Review of Plans: Tappan Fire District, 300 Western Highway, Tappan NY  
Section 74.18 Block 2 Lot 35 R-15 zone

Subject: **Tappan Fire District**  
Prepreliminary/Preliminary/Final  
Site Plan and SEQRA Review  
300 Western Hwy, Tappan  
74.18-2-35; R-15 Zoning District, 2.07 Acres

Submission reviewed: Site Plan Approval Drawings dated July 15, 2022 by Atzl, Nasher, & Zigler PC

**SITE DEVELOPMENT PLAN**

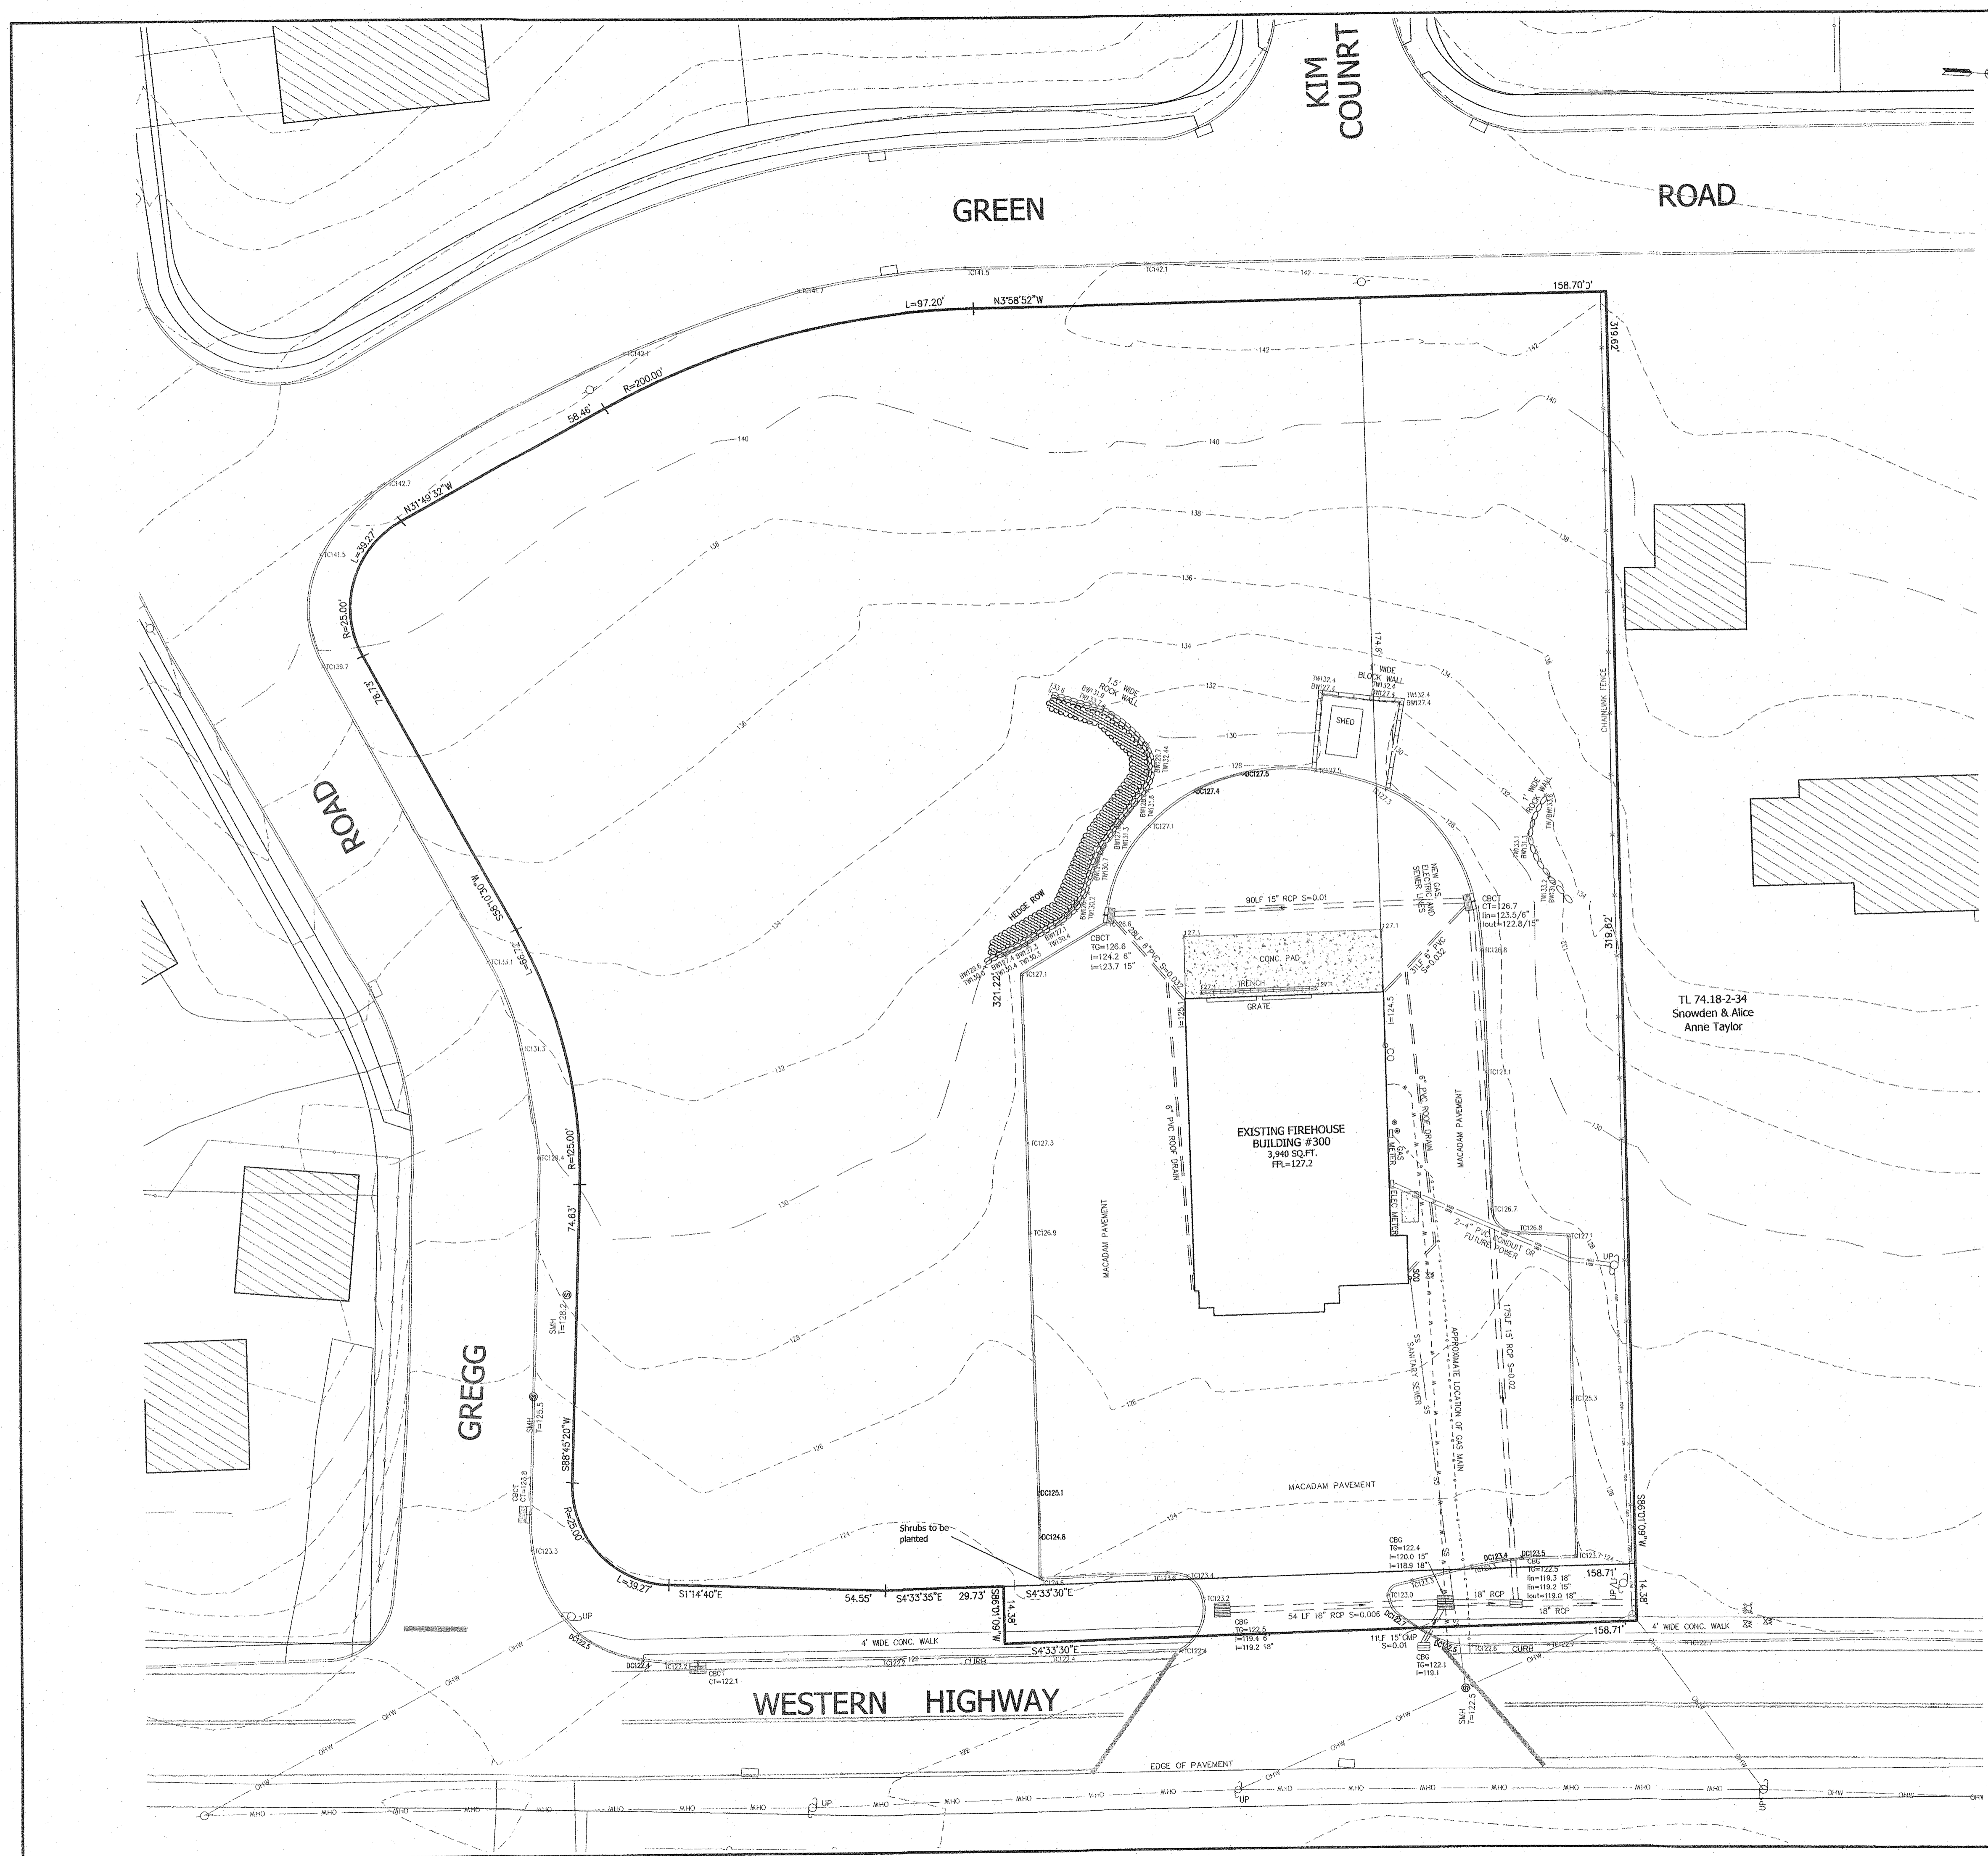
- 1.) Application will be referred to the Zoning Board for Front & Side Yard Variances
- 2.) Chapter 2, Section 2-4(A) requires ACABOR approval
- 3.) Please provide a complete parking plan with all striping. Please calculate parking at 1 space per 200 sf. And list (calcs) on site plan
- 4.) Please provide N,S,E,W Elevation Drawings
- 5.) Provide directions arrows on Grading Plan depicting drainage flow over property and from roof drains.
- 6.) Please depict existing curb on Western Hwy as being accessible
- 7.) If the rise between floors is greater than 12', please add landing.
- 8.) It appears that the assembly area on the top floor is inaccessible. Please remedy.
- 9.) Please demonstrate at least one bathroom is ADA compliant
- 10.) The scale on the architectural drawings appears to be inaccurate.
